Addendum #2

Project Name: Concordia STEM
Seward, NE
Project No.: 16022-05
Date Issued: May 8, 2018
Bid Date: Thursday, May 17, 2018

**MAIN LEVEL INSTALLATION LAYOUT FOR
MOHAWK LICHEN COLLECTION**

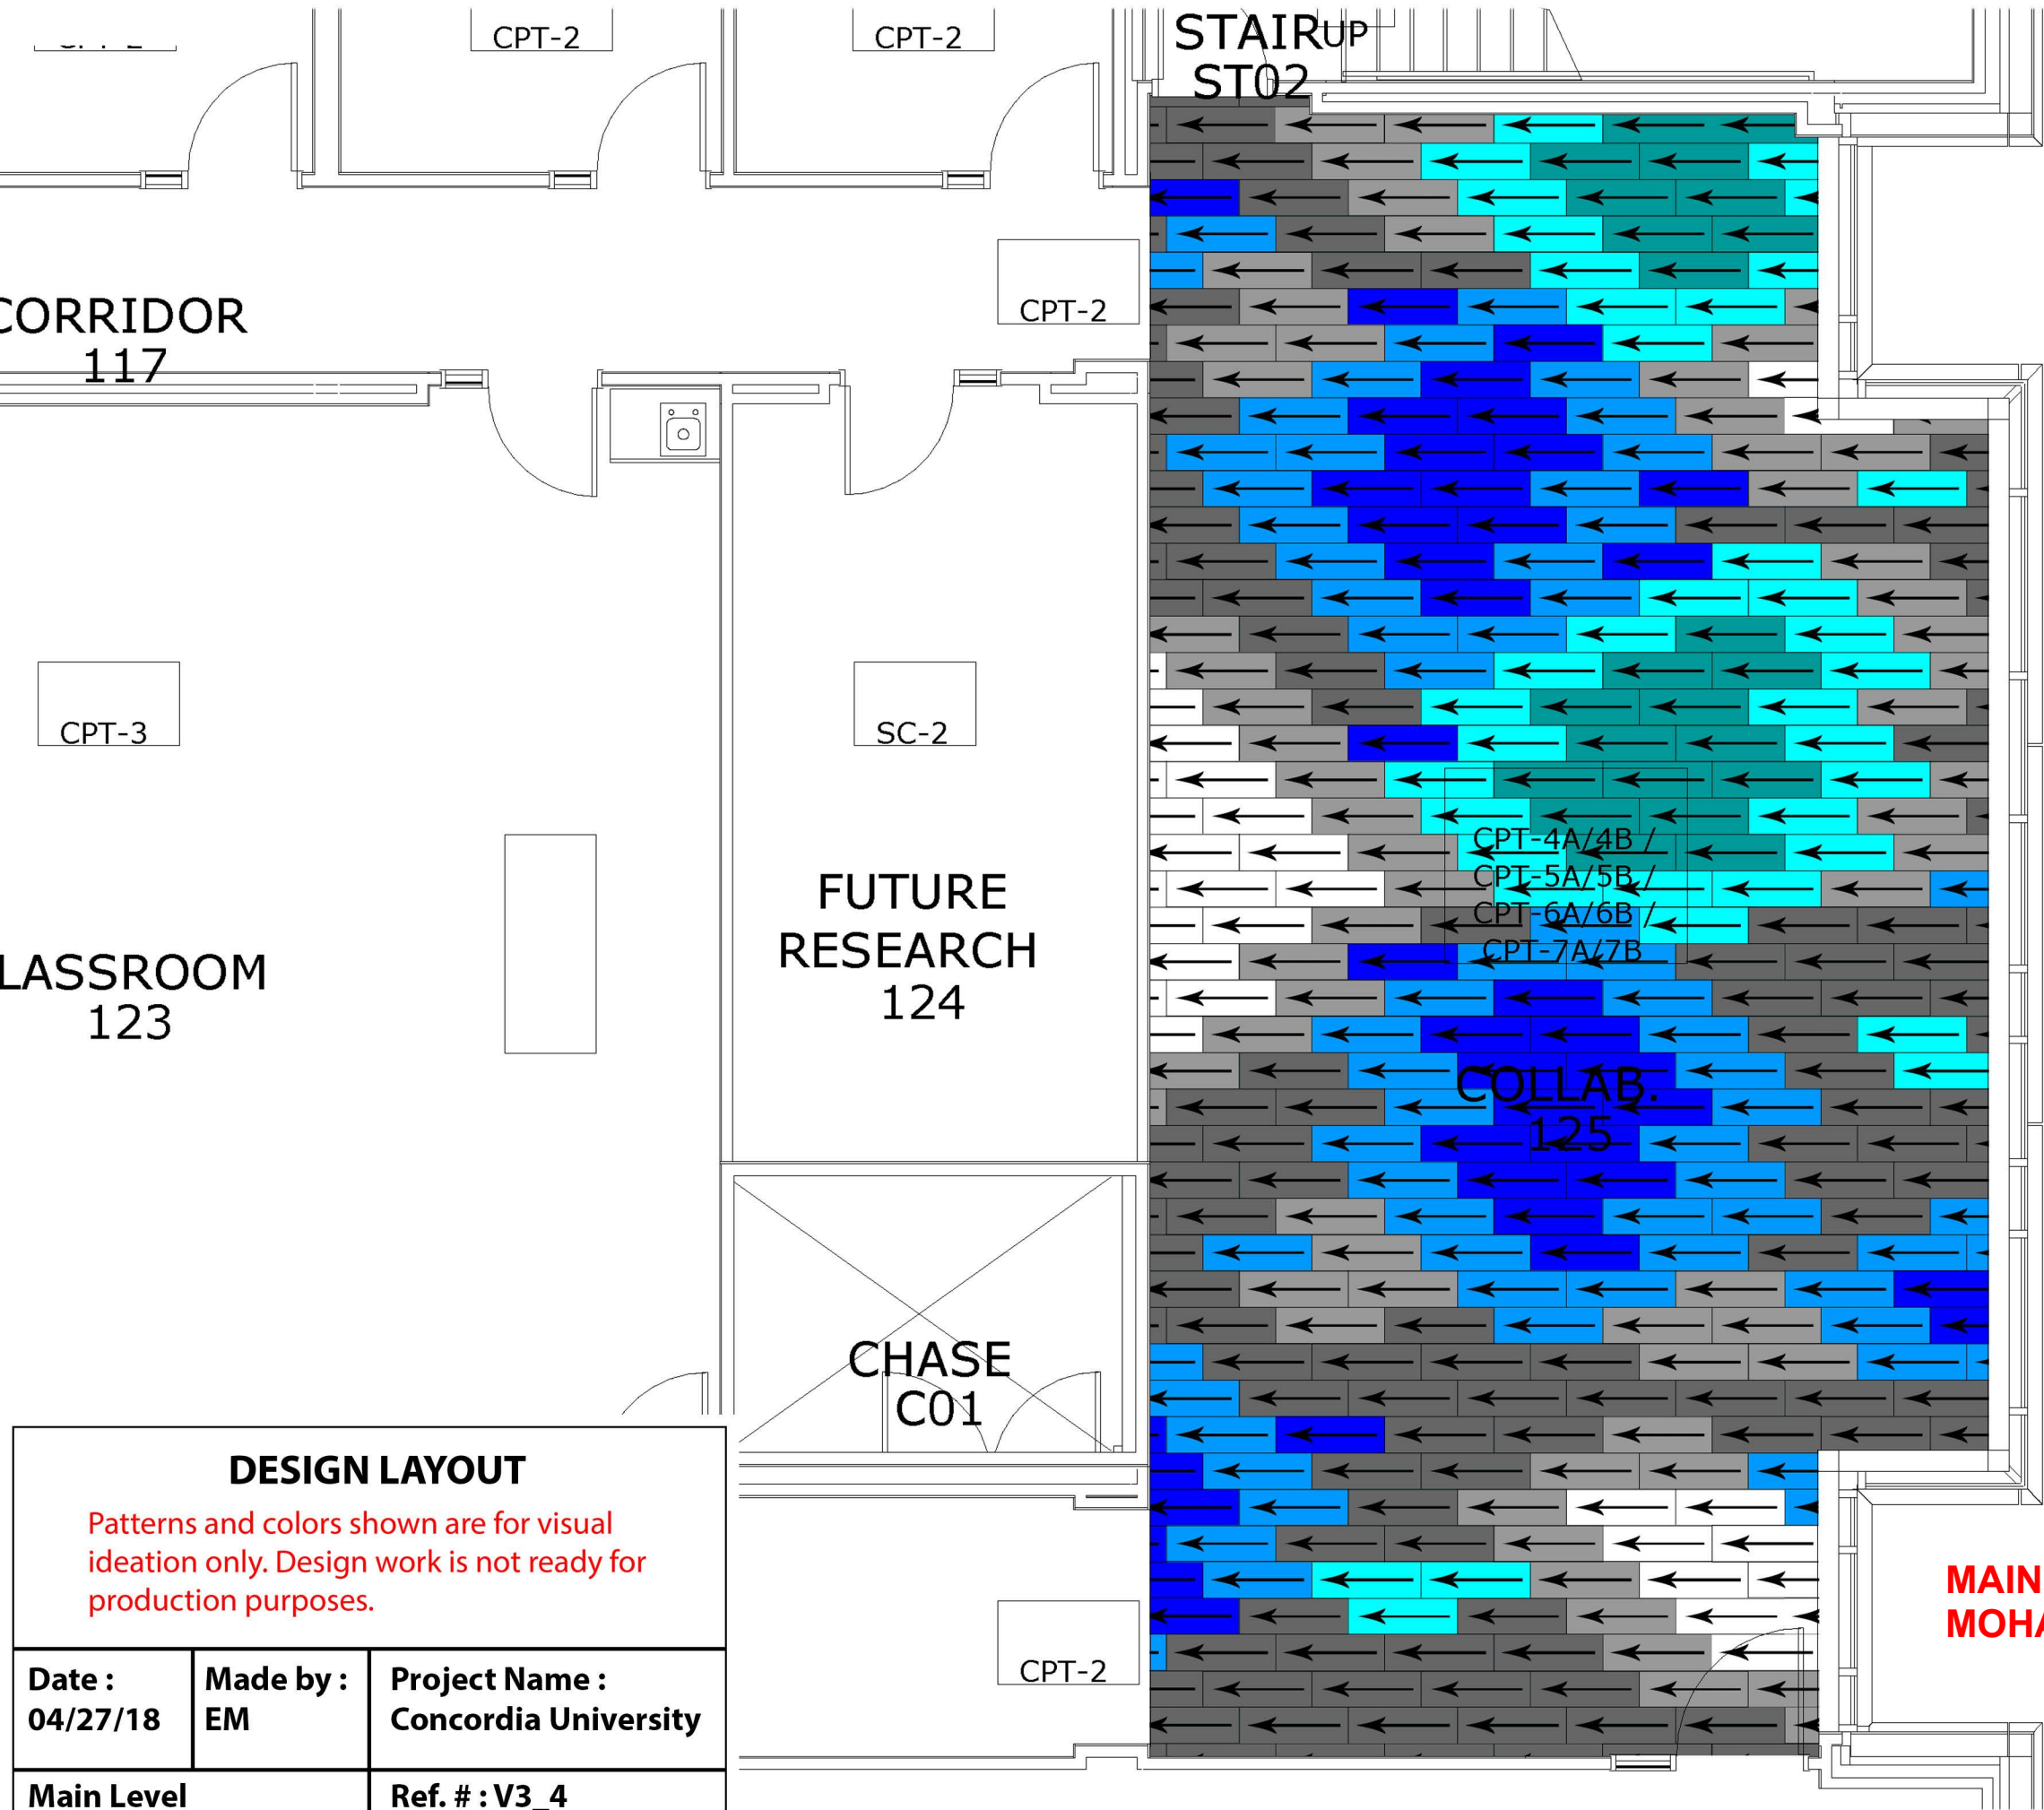
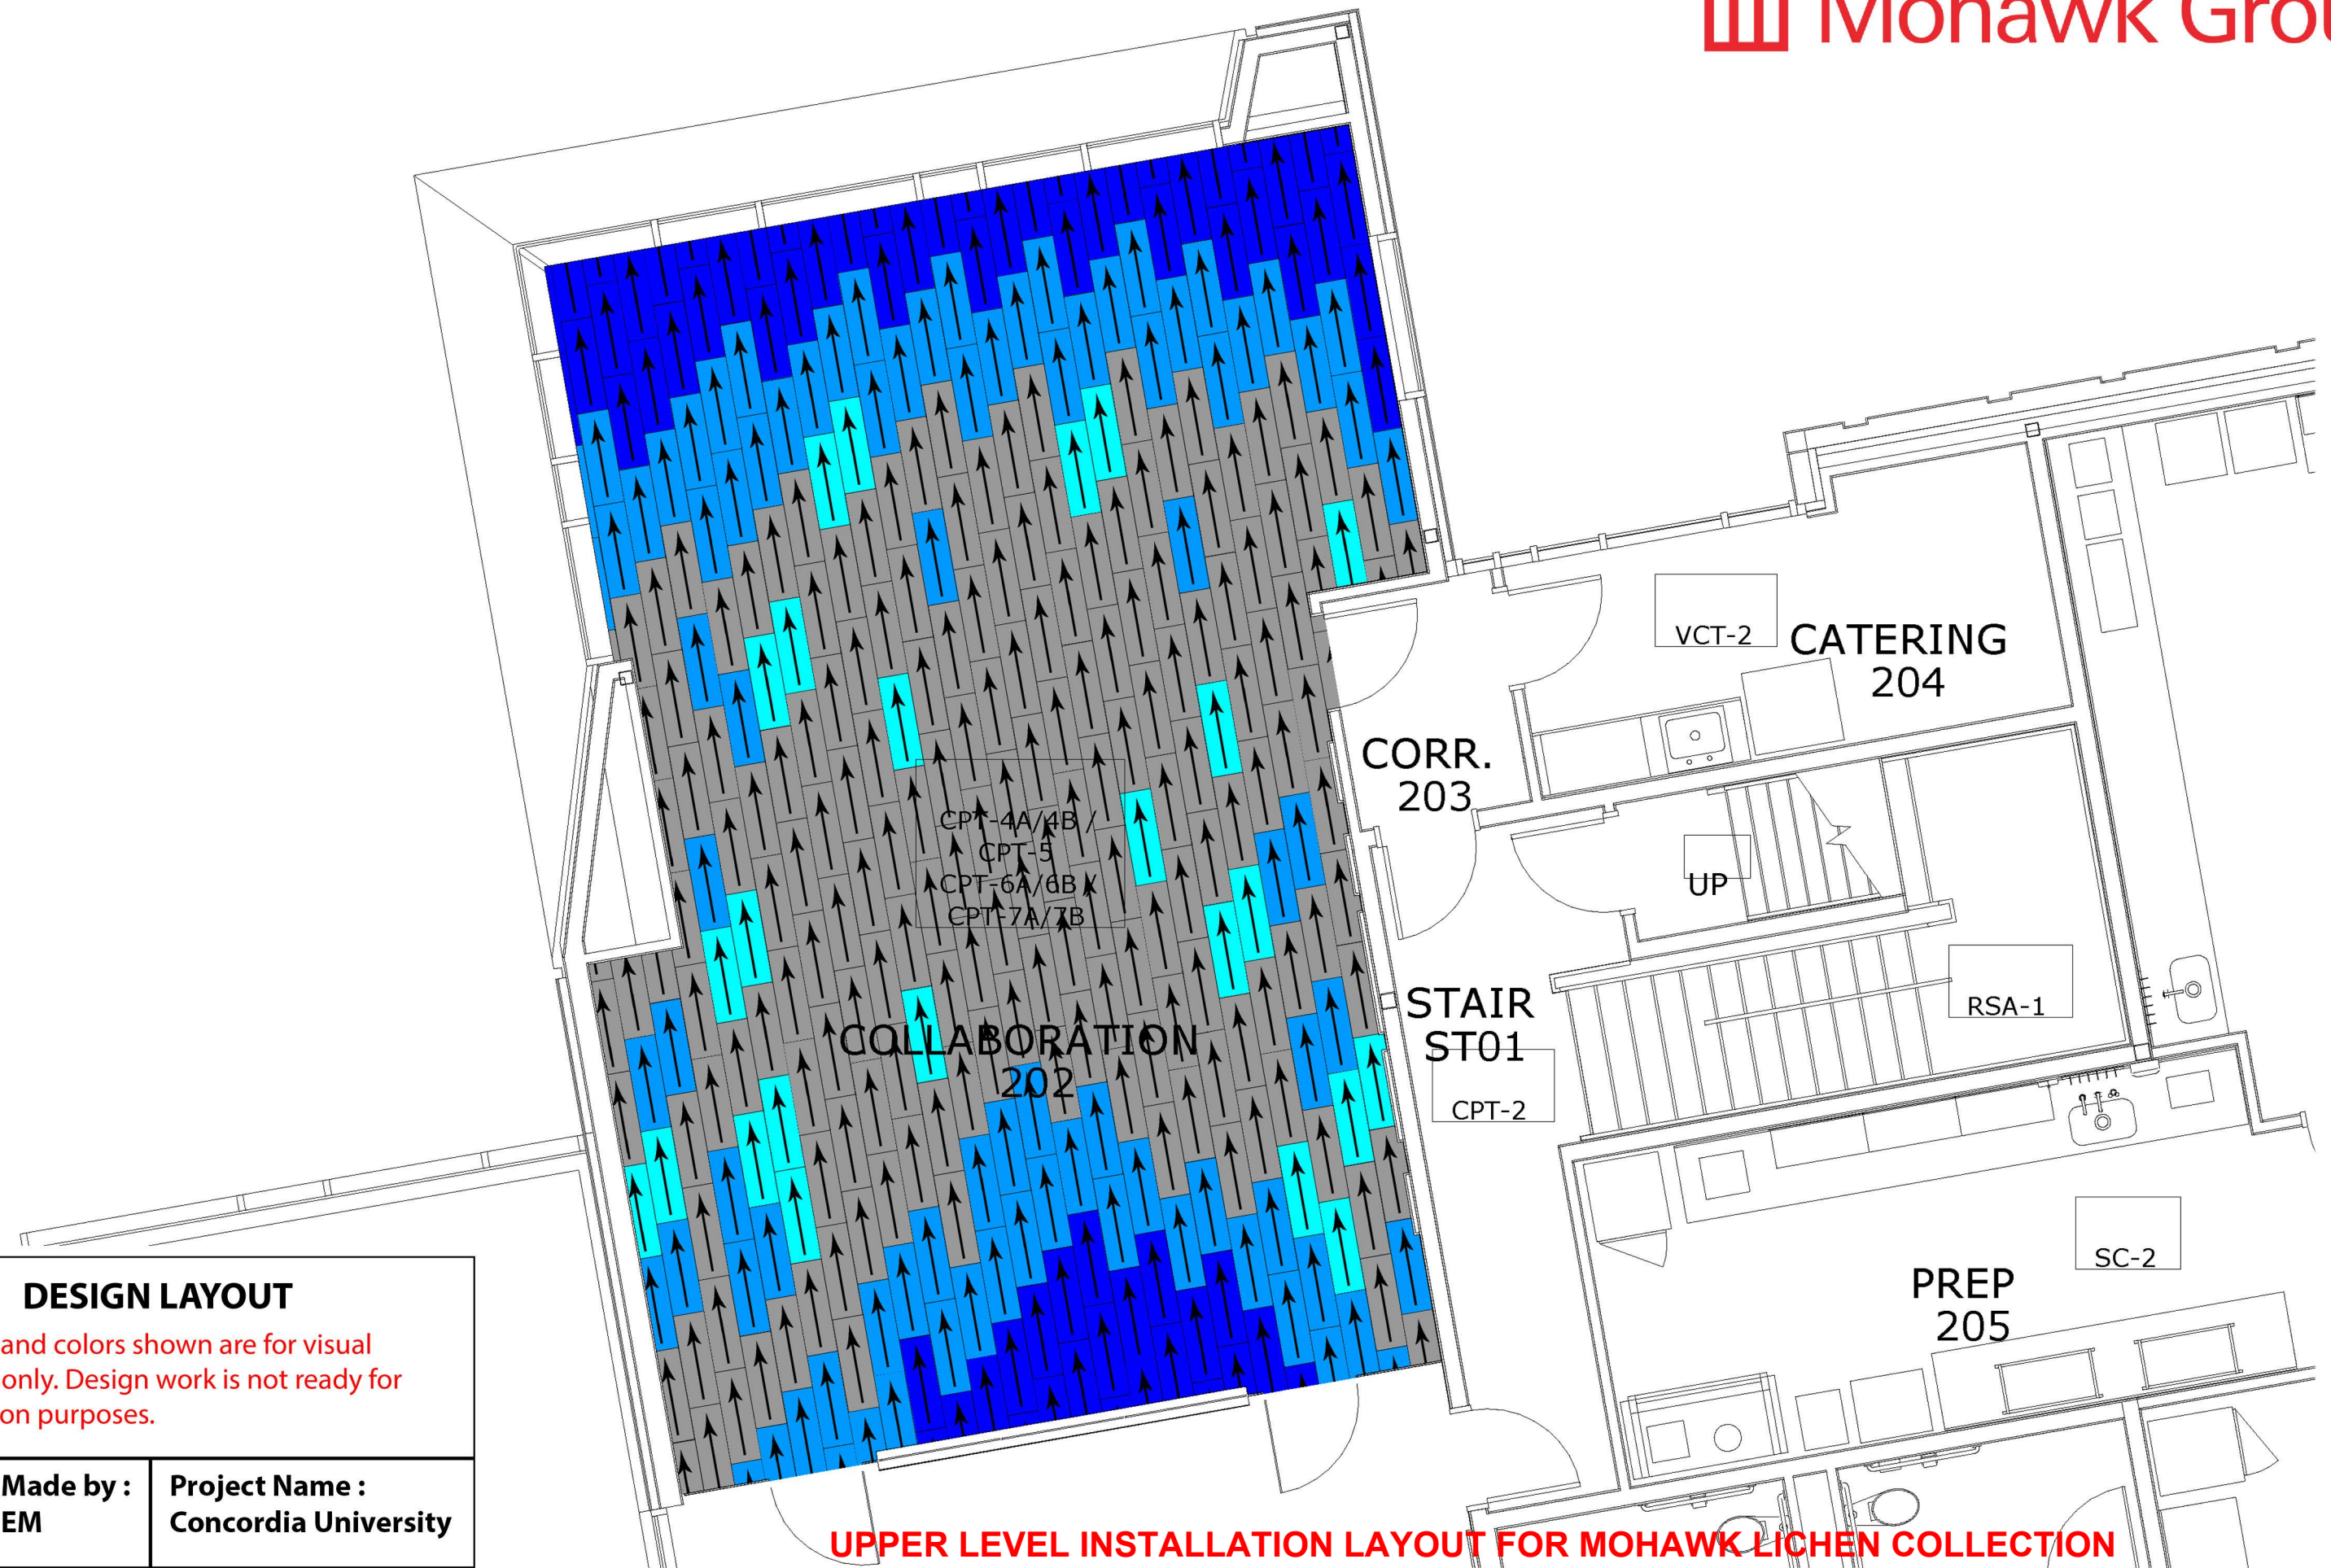
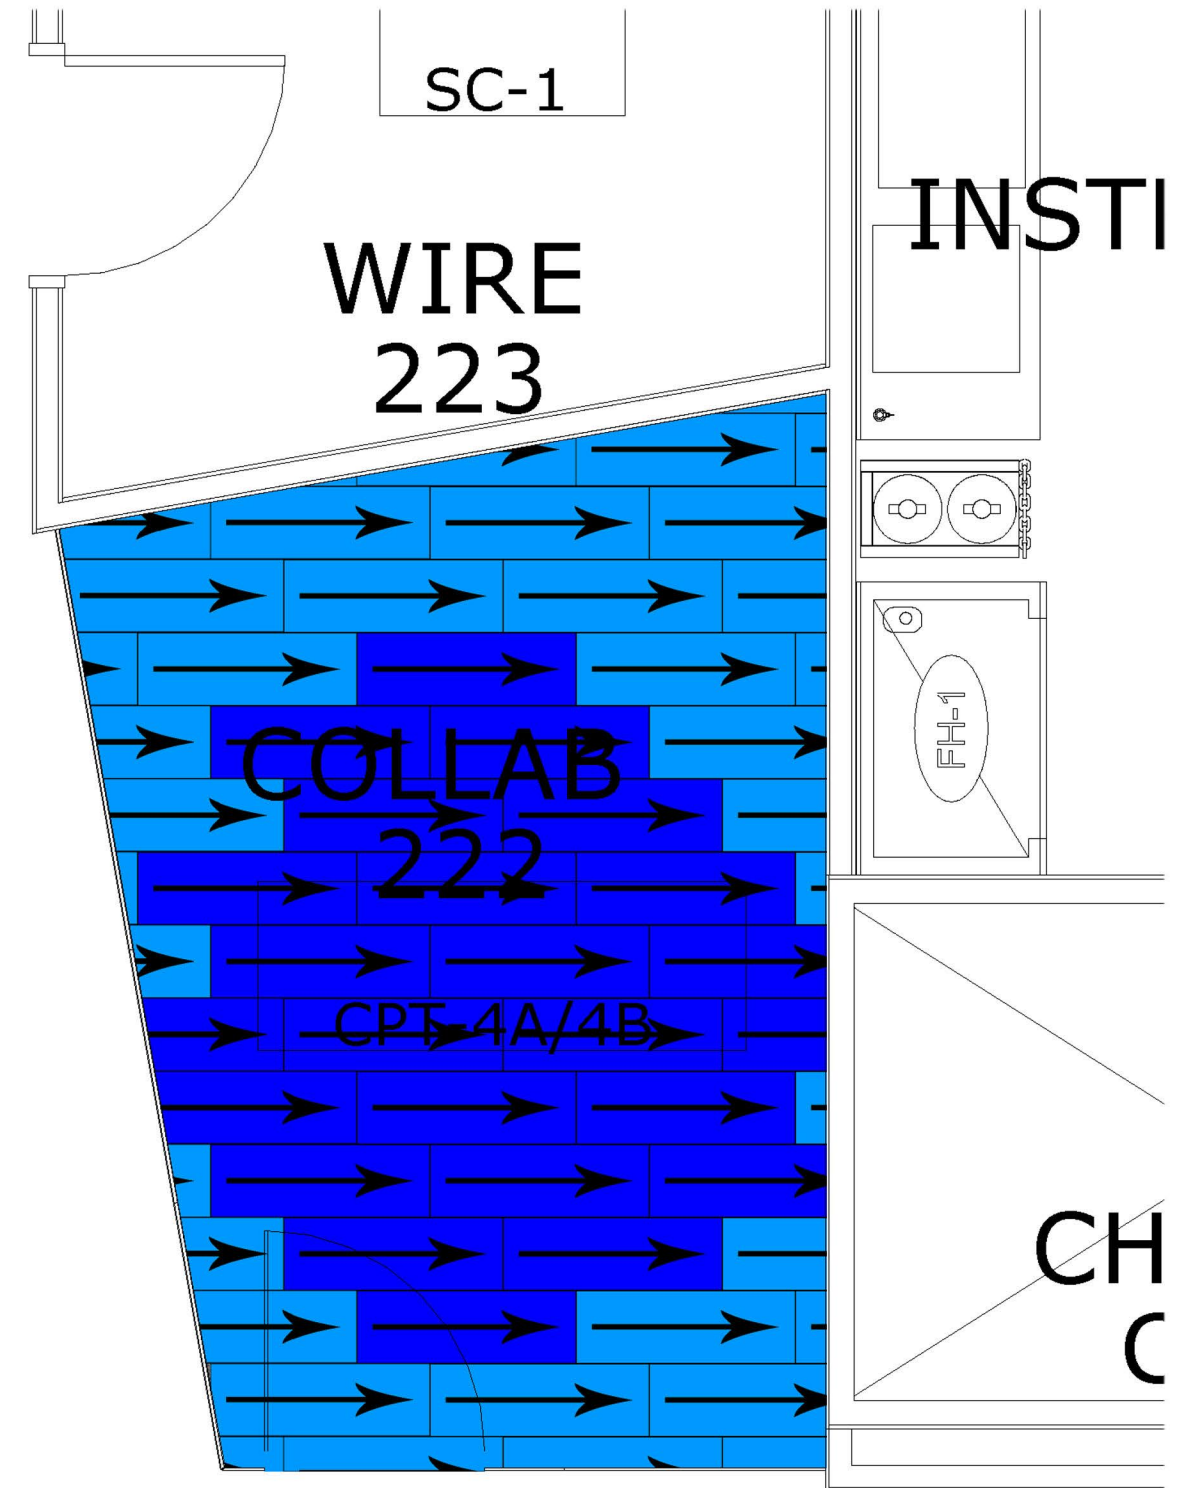
Question: *The areas of patterned carpet reference Note 4 on the plans, stating to see the manufacturer's layout included in specifications. Where is this layout with the specifications? We cannot find it for reference.*

Response: The attachments have been added to this addendum and are identified as 096813-A "Tile Carpeting Lichen Installation Layouts"
